## SITE INSTRUCTION

PROJECT: HAMPTON MANOR  
25 BAKER HILL BLVD  
STOUFFVILLE, ONTARIO

SITE INSTRUCTION NO.: E-31

**PURPOSE:** Revise as per ID drawings.

TITLE  
**PARKING P1 LEVEL - A  
ELECTRICAL**

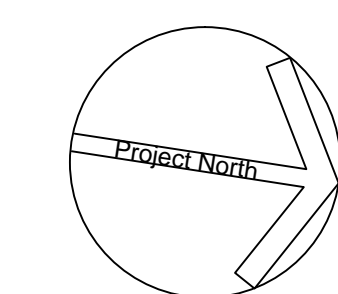
**1.0 Reference Drawings E-2A (Parking P1 Level A - Electrical) Issued**

1.1 Revise: Lighting fixture layout as shown.

TITLE  
**GROUND FLOOR PLAN - B  
ELECTRICAL**

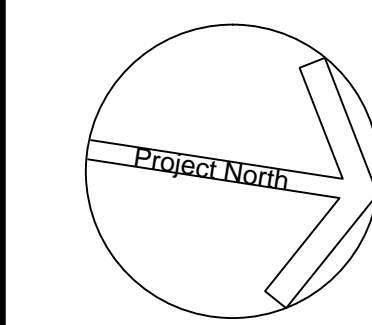
**2.0 Reference Drawings E-3B (Ground Floor Plan B - Electrical) Issued**

2.1 Add: Two type 'R5' lighting fixtures as shown.
